# 802.3dj D1.1

## Comment Resolution

### Optical Topics

Tom Issenhuth (Huawei)  
Matt Brown (Alphawave Semi), 802.3dj Chief Editor

Figure 180-2—Block diagram for 800GBASE-DR4 transmit/receive paths

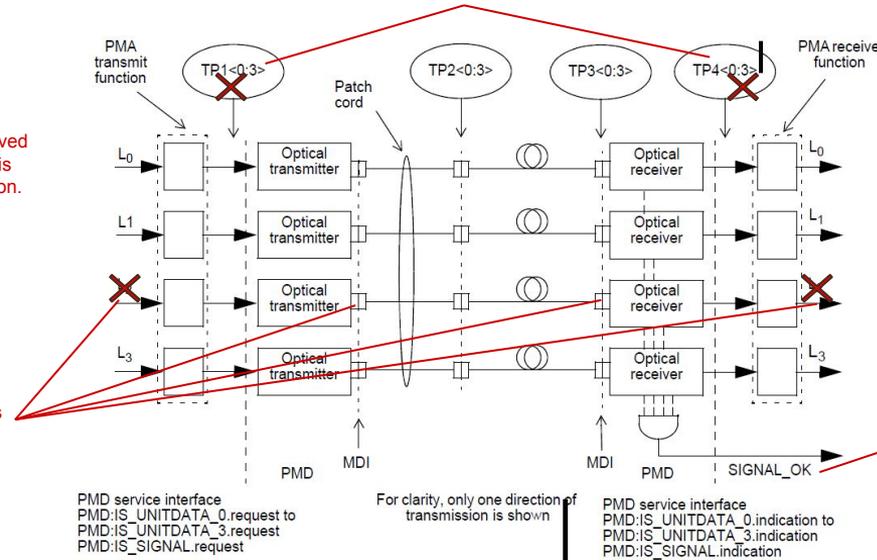
TP1 and TP4 is never defined in any of the optical clauses in 802.3dj and is not necessary. Should be deleted from diagram.

SIGNAL\_OK signal is received from PMA or Inner FEC as is processed by the ILT function. Need to depict this.

Rather than labelling the inputs to the transmit function (these can be arbitrary) label the output so that mapping to MDI pins can be defined. Adopt signal labelling for KR/CR PMDs.

With adoption of ILT, SIGNAL\_OK (sent to PMA or Inner FEC) is set by the ILT function, not the signal detect function. Change SIGNAL\_OK here to global\_PMD\_signal\_detect. Show SIGNAL\_OK emanating from the ILT function.

As above, TP1 and TP4 is never defined in any of the optical clauses in 802.3dj and is not necessary. This text should be deleted.

# Proposal: The resulting diagram for xBASE-DRn/DRn-2

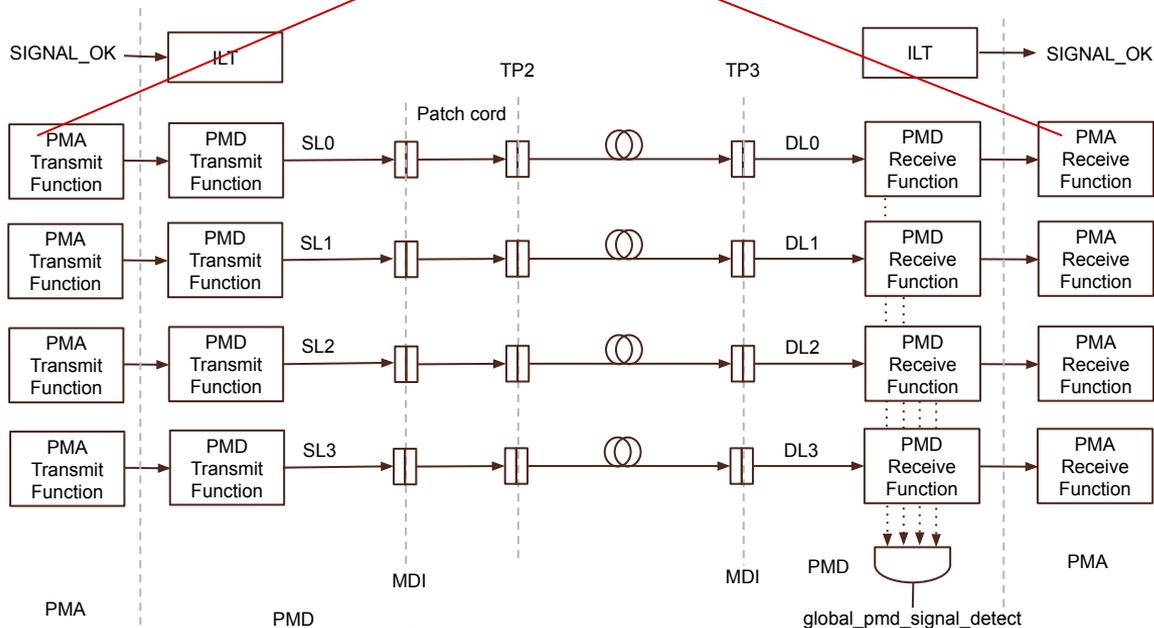
Figure is missing PMD transmit function and PMD receive function

Add PMD transmit function between PMA and optical transmitter and PMD receive function between optical receiver and receive PMA.  
 Also add following label between PMD transmit function and optical transmit "Sli"  
 Also add following label between optical receive and PMD receive function "DLI"  
 PMD Signal\_OK should be connected to the PMD receive function.  
 Alternatively you could combine PMD TX function with optical TX and optical RX with PMD RX function.  
 In Figure 180-2 L0-L3 (left) at PMA input can be replaced with SL1-SL3 and L0-L3 (Right) with DL0-DL3.

These comments ask to update the optical PMD block diagrams to better address link training:

- show the complete transmit and receive functions
- label TX and RX lane explicitly and uniquely; proposes using same labels used for CR/KR
- associate the SIGNAL\_OK signal with the receive function

PROPOSED ACCEPT IN PRINCIPLE.  
 Background and proposed changes are provided in the "ILT" slides in following editorial presentation for CRG review.  
 URL:issenhuth\_3dj\_01\_2409

For DRn-2 PMDs, replace "PMA" with "Inner FEC"

REPLACE BLOCK DIAGRAM

Figure 180-7—400GBASE-DR2 optical lane assignments

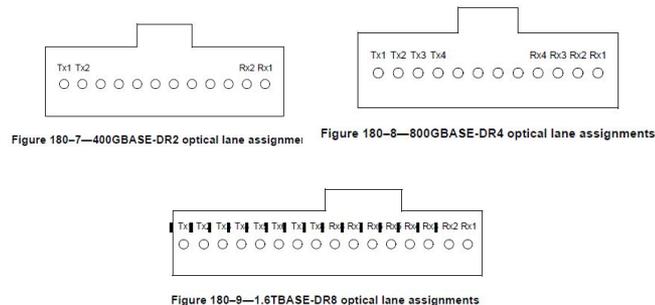
CI 180	SC 180.8.3.1.1	P 386	L 3	# 100
Ghiasi, Ali Ghiasi Quantum/Marvell				
Comment Type	TR	Comment Status	D	ILT
Add sentence describing where TX/RX data are coming				
<i>SuggestedRemedy</i>				
Tx1 and Tx2 data are sourced respectively from SL1 and SI2. Rx1 and Rx2 data propagate respectively to DL1 and DL2. Also add reference to Figure 180-2				
Proposed Response	Response Status W			
PROPOSED ACCEPT IN PRINCIPLE.				
Background and proposed changes are provided in the "ILT" slides in following editorial presentation for CRG review. URL/issenhuth_3dj_01_2409

These comments ask for text explicitly linking the each RX and TX lanes to a specific pin on each of the optical connector types.

Table 180-x—Mapping PMD signals to MDI pins	
PMD signal	MDI pin
SL0	TX1
SL1	TX2
SL2	TX3
SL3	TX4
SL4	TX5
SL5	TX6
SL6	TX7
SL7	TX8
DL0	RX1
DL1	RX2
DL2	RX3
DL3	RX4
DL4	RX5
DL5	RX6
DL6	RX7
DL7	RX8

# Proposal: The resulting diagram for 800GBASE-LR4/FR4/FR4-500

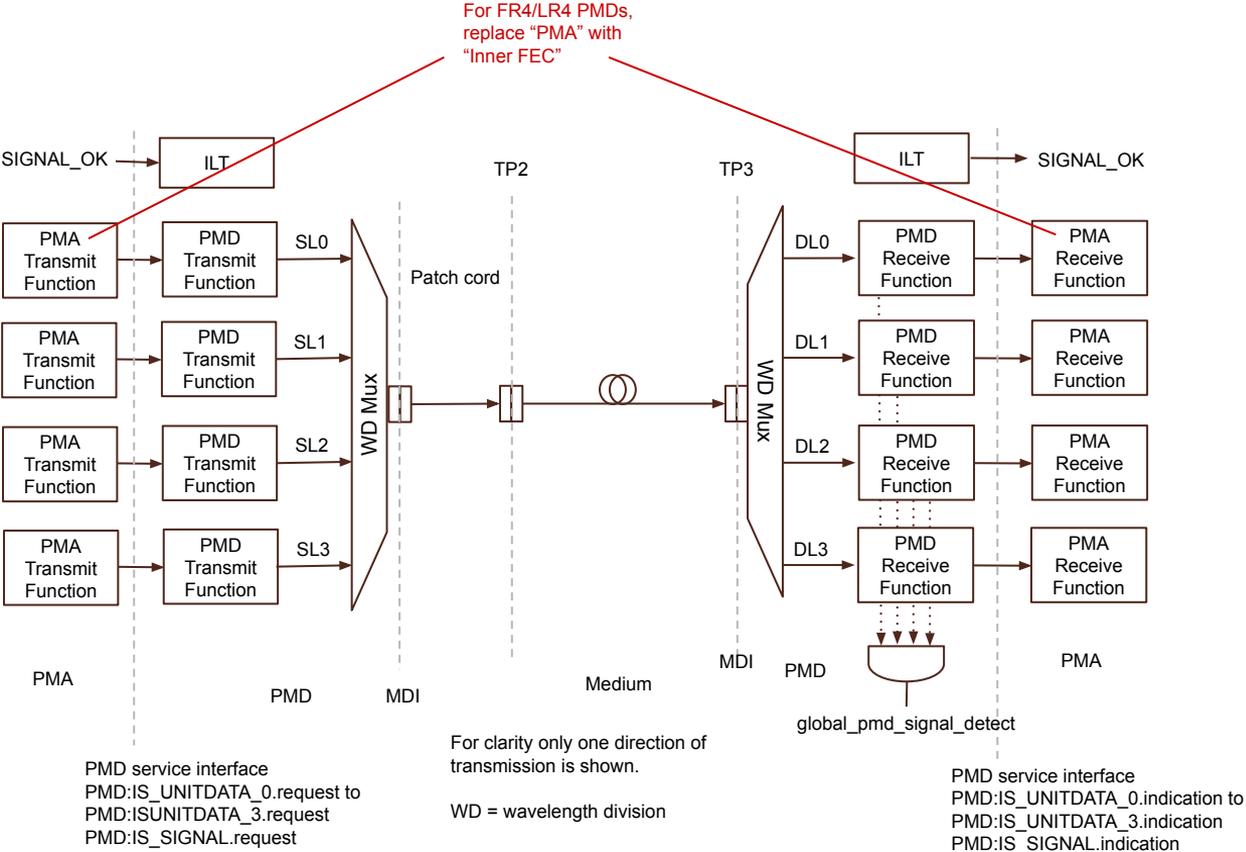
Figure is missing PMD transmit function and PMD receive function

Add PMD transmit function between PMA and optical transmitter and PMD receive function between optical receiver and receive PMA.  
 Also add following label between PMD transmit function and optical transmit "Sli"  
 Also add following label between optical receive and PMD receive function "DLI"  
 PMD Signal\_OK should be connected to the PMD receive function.  
 Alternatively you could combine PMD TX function with optical TX and optical RX with PMD RX function.  
 In Figure 183-2 L0-L3 (left) at PMA input can be replaced with SL1-SL3 and L0-L3 (Right) with DL0-DL3.  
 Use label L0-L3 or Symbol (Lamda0-Lamda3) at input and output of the Mux/De-mux. If you change L0 to Lamda0 then also need to change label in tbae 183-3

PROPOSED ACCEPT IN PRINCIPLE.  
 Resolve using the response to comment #98 .

# Proposal: per-interface and per lane (bidirectional) nature of link training

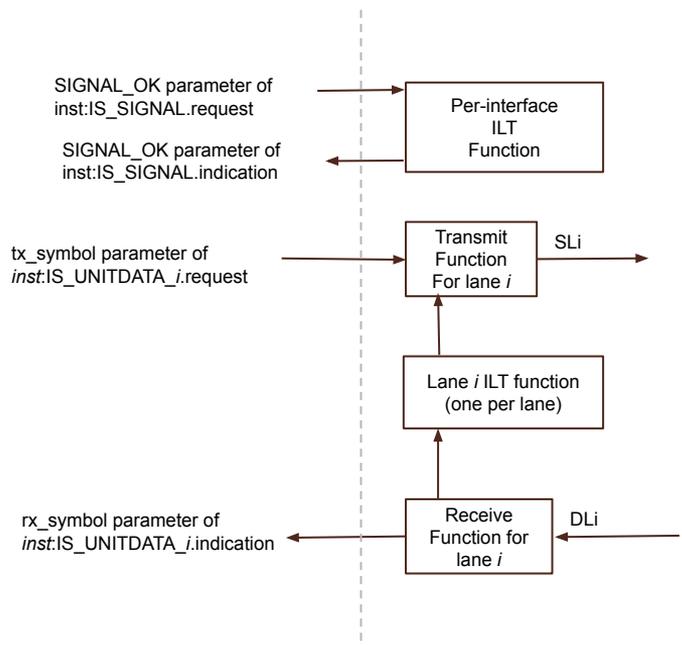
There is a piece missing from the optical block diagram (e.g., Figure 180-2), as well as the electrical block diagrams (e.g., Figure 163-2) relating to the bidirectional nature of ILT. This is relevant to electrical PMDs, optical PMDs, and AUI components.

The ILT signaling per lane is bidirectional. In other words, there is a function that acts on behalf of each transmitter-receiver pair on lane  $i$ .

There is also an ILT function that acts on the set of lanes for a PMD or AUI component.

A diagram similar to this should be added to Annex 176A along with appropriate explanatory text. A reference to this figure and related explanation can be added to the ILT subclause for each PMD and AUI.
